HOSHIZAKI AMERICA, INC.

SERVICE BULLETIN

SB10-0008

Subject: HOT GAS VALVE AND STRAINER

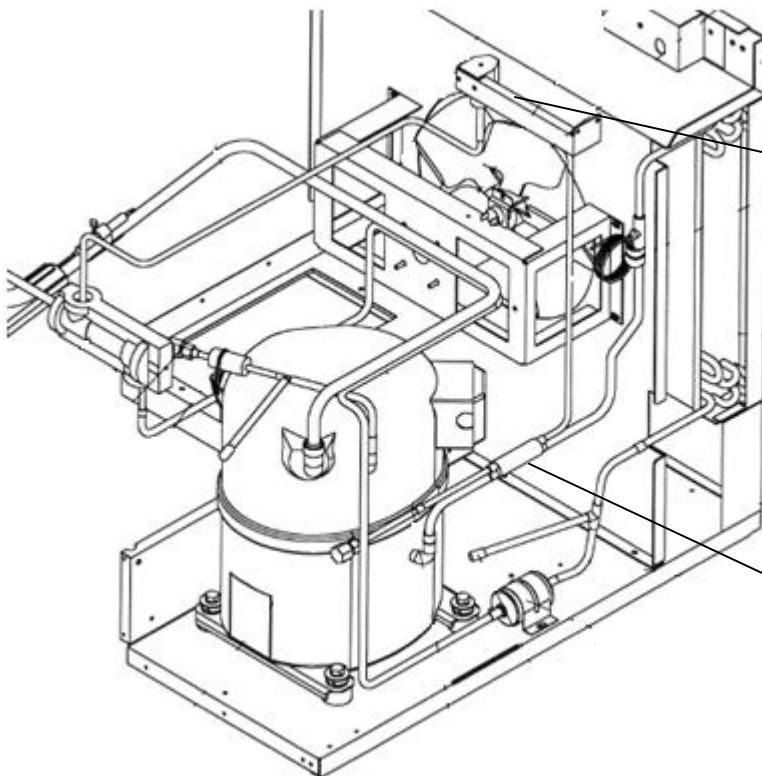
The strainer is a protection device for the HGV. When replacing the HGV, it is required to replace the strainer and filter drier on all units. Look for direction arrow on strainer and insure that it is pointing at the inlet of HGV.

*Note: All warranty claims for replacing HGV must also replace the strainer and drier. All warranty parts must be returned to the distributor with the claim. Repairs not including strainers and drier are incomplete and may be denied.
